# CONTRACT CHANGE ORDER FORM

Contract Number: 2015-61 Change Order Number: **FM-01**

Project Description: **Bismarck WWTP Trickling Filters – Media Equipment Procurement**

# Change Order

- Exhibit B-1: BIOdek Support System Details

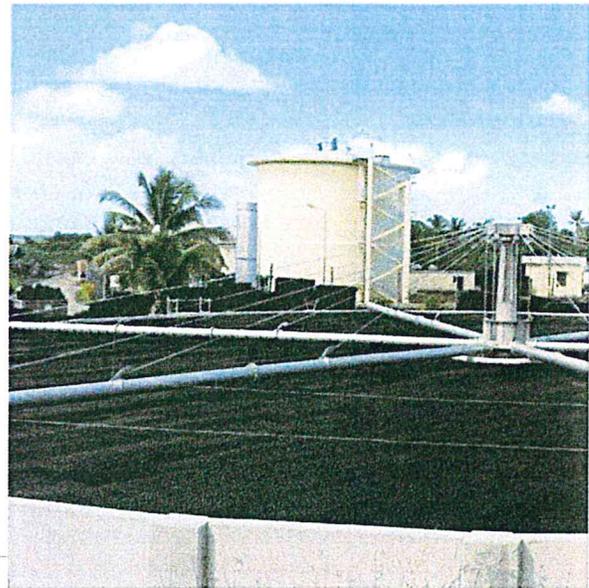
At the request of ENEXIO, an alternate media support system has been proposed and is included as part of this change, to offset increased storage and handling costs.

In lieu of the originally specified, submitted, and approved polypropylene PIERdek/Buzon pedestal supports, ENEXIO is directed to provide an alternate support system, consisting of pedestals that combine PVC stanchions and slope correcting base plates. The pedestals will support FRP beams and pultruded FRP grating, the will be held down by stainless steel hardware. Details for this system, including installation instructions, can be found in the attached Exhibit B-1. Per project correspondence, schedule 80 PVC is to be used in lieu of the schedule 40 PVC pipe stanchions noted in the details and installation instructions. All fastening and misc. hardware to be stainless steel, glass-reinforced ABS, or PVC.

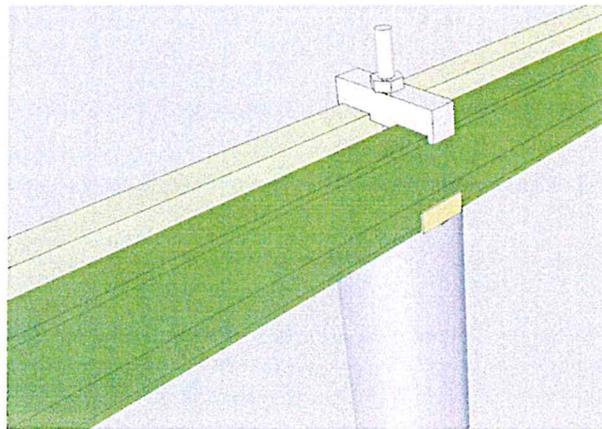
Screw the bolts (part of the fixing set) into thread of the disc , let ~140mm (5-1/2") out.

Push the lower bracket of the fixing sets over the bolt with the folds reaching upwards.

Place a pair of 20ft FRP beams on the lower bracket over 5 stanchions. The ends of the beams shall be in the middle between two stanchions. Place the pairs in a staggered mode

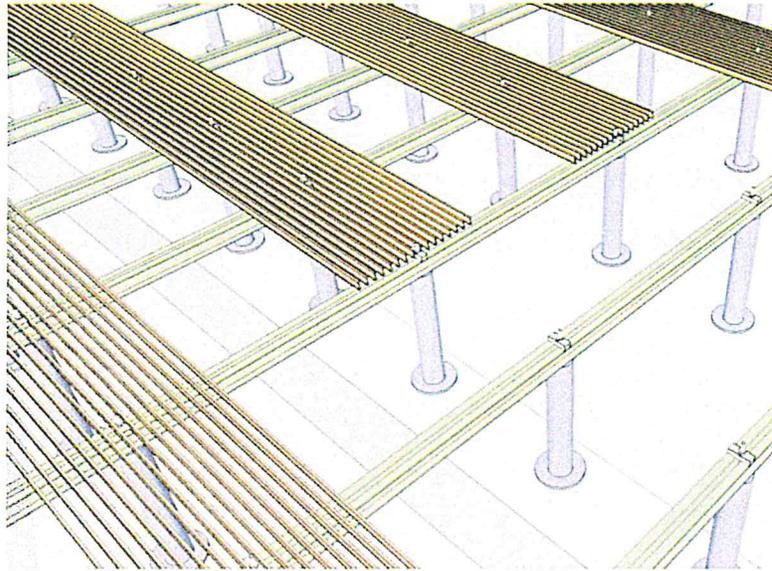
Since the perimeter grating isn't perpendicular to the FRP beams, the middle PVC block bracket cannot be used in the fashion. Wherever this bracket serves as a guide to interlock with the pultruded grating, the block has to be turned upside-down to allow rotation .
